Metropolitan Development Commission Plat Committee (September 10, 2025) Meeting Agenda

PLAT COMMITTEE

September 10, 2025

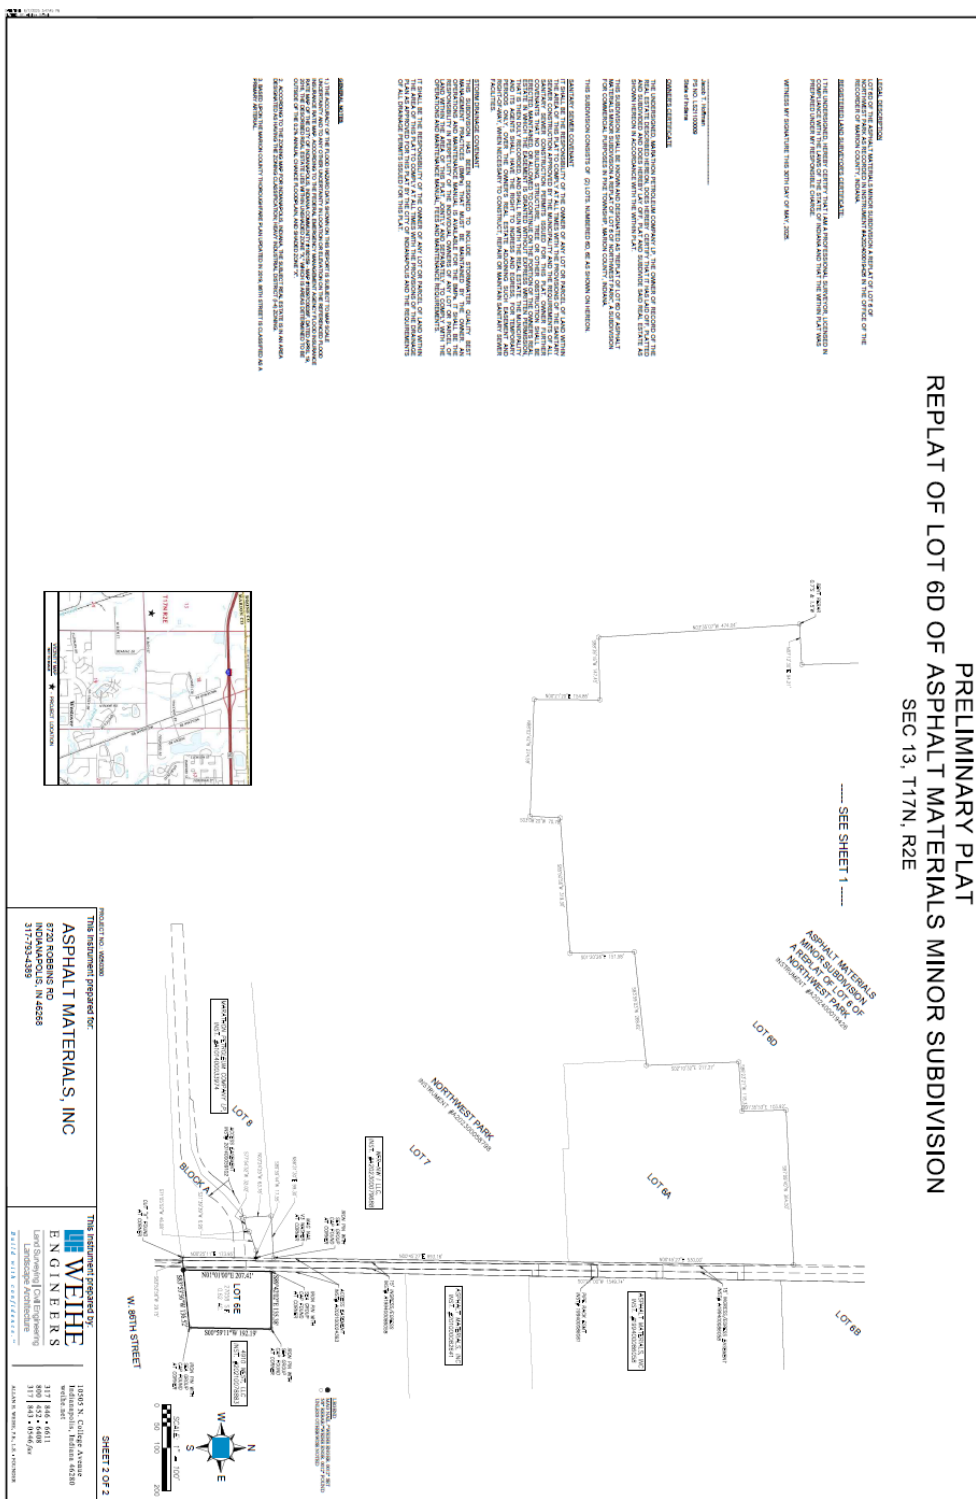
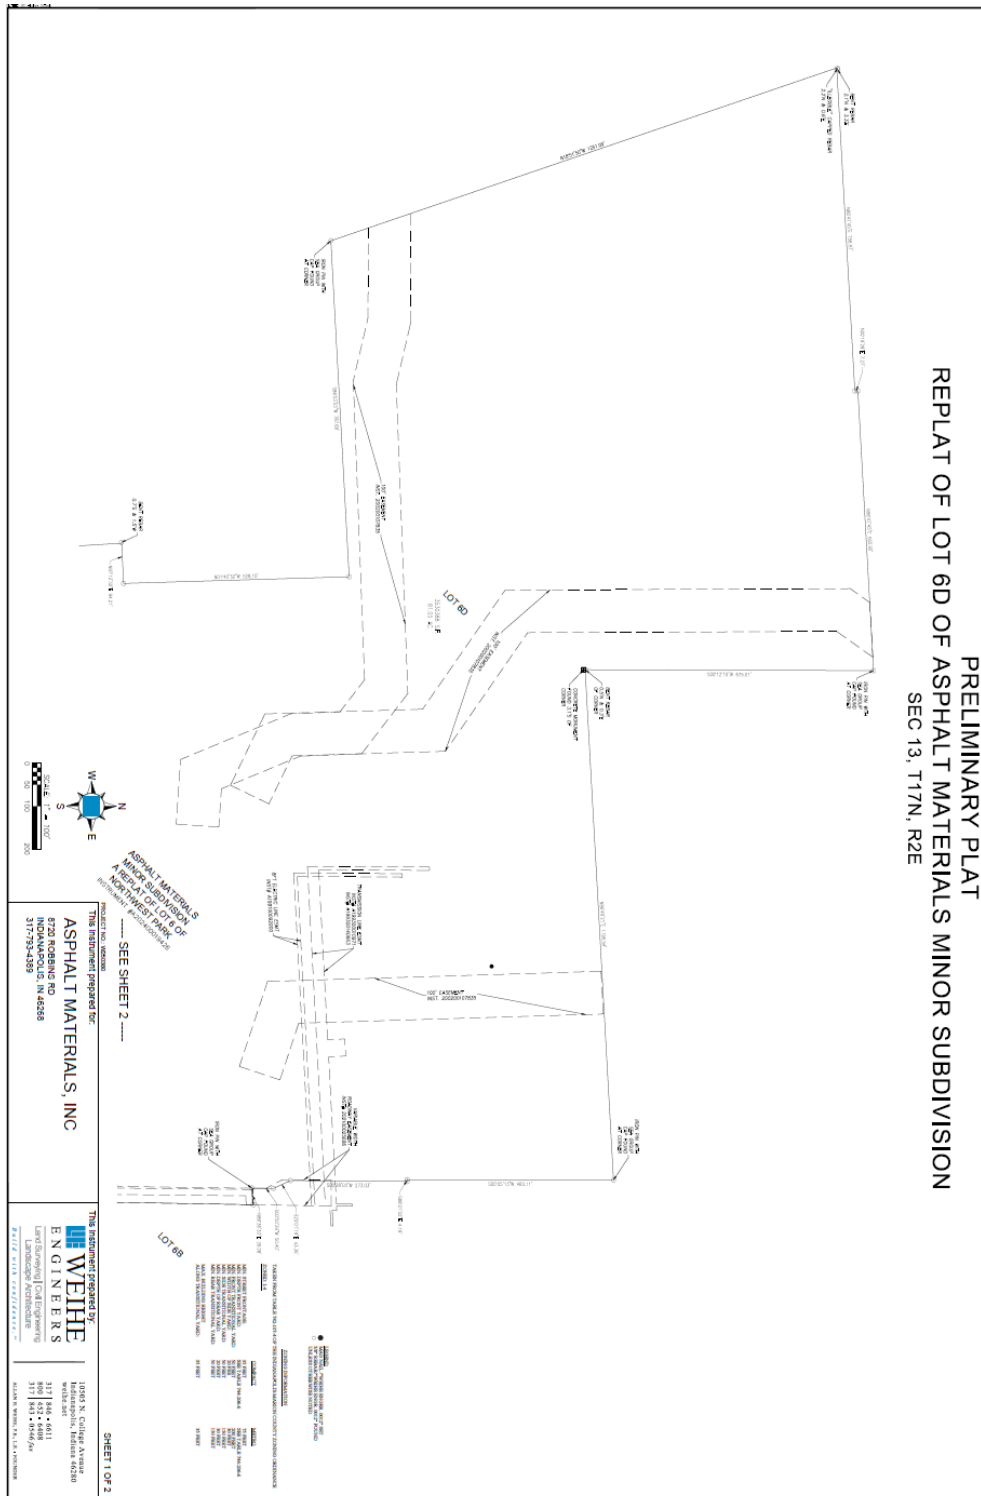
When visiting the site, staff did note any physical limitations of the land that would prevent the installation of sidewalks along the frontage (see Photos 5-6). The Ordinance indicates that waivers may be contemplated in instances of *extreme* difficulty caused by topography or grade change, which does not appear to be the case for this property (744-301.G). Additionally, installation of an expansive and interconnected sidewalk network (even in industrial areas) is a core component of the City's Vision Zero initiative to reduce traffic fatalities and promote walkable communities.

Staff also notes that this stretch of 86th Street is identified by the Greenways Plan for potential future placement of the 86th-82nd Street Connector. The specific design, placement, and alignment of the connecting greenway is still in the early stages of development, but the Plan identifies this as an area where increased walkability would serve as a valuable connection between where people live and work and would further City goals of transportation connectivity, economic development, and potential connections to trails in Hamilton County (such as the Big 4 Trail). For these reasons, staff recommends denial of the waiver request.
